August 4, 1980

Reference: Docket No. 99900259/80-01

In response to your letter dated July 16, 1980, the following information is submitted as a supplement to our audit reply of July 3, 1980:

Item E.

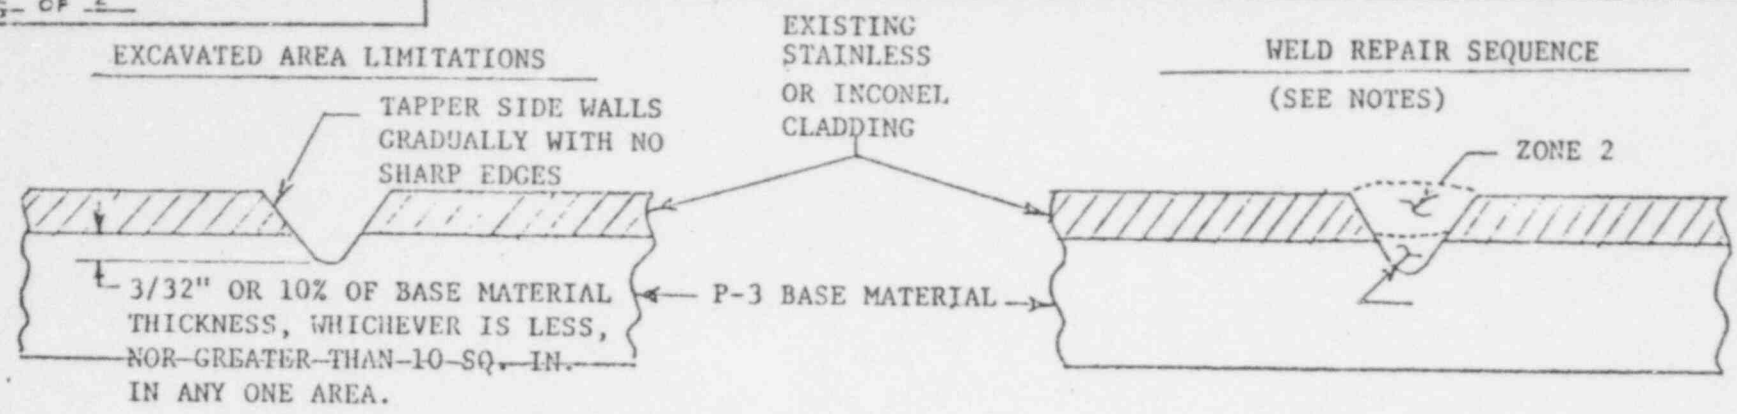
- 1) The base metal repair was started and completed on the same shift by one qualified Welder. The Temper Bead Technique was verified by both the Manufacturing Foreman and the Authorized Nuclear Inspector, who had imposed an A.N.I. "Hold" point on the repair.
- 2) A review of sheet 2 of WMC-10-11, Rev. 01 (attached) used for the Inconel Cladding, revealed that the foreman had initialed each sequence of the repair upon its completion. The pictorial presentation in the top right corner has omitted the words "Zone 1" following the lower arrow. Consequently, the foreman interpreted the unidentified area to be the base material and Zone 2 to be the cladding. When circling the area for the Inconel Cladding on sheet 1 of the D.W.P. , he circled only Zone 2. The master copy of D.W.P. WMC-10-11 has been corrected to reflect Zone 1.

- NOTES: 1. If base material is exposed within the excavated area, repair weld using the following sequence:
- A. Ensure that the area of exposed base material does not exceed the limits specified in the above sketch. *RLR*

- B. Preheat and maintain the repair area at a minimum temperature of 350°F during all welding. Interpass temperature shall not exceed 450°F. *RLR*
 - C. Cover all exposed base material (Zone 1) by depositing a single layer of weld deposit using 3/32" dia. electrode. *RLR*

- D. Remove by grinding, part of the first layer (Zone 1) prior to depositing additional layers (Zone 2). *RLR*
 - E. Deposit a minimum of one additional layer (Zone 2) using 3/32" or 1/8" dia. electrode. *RLR*
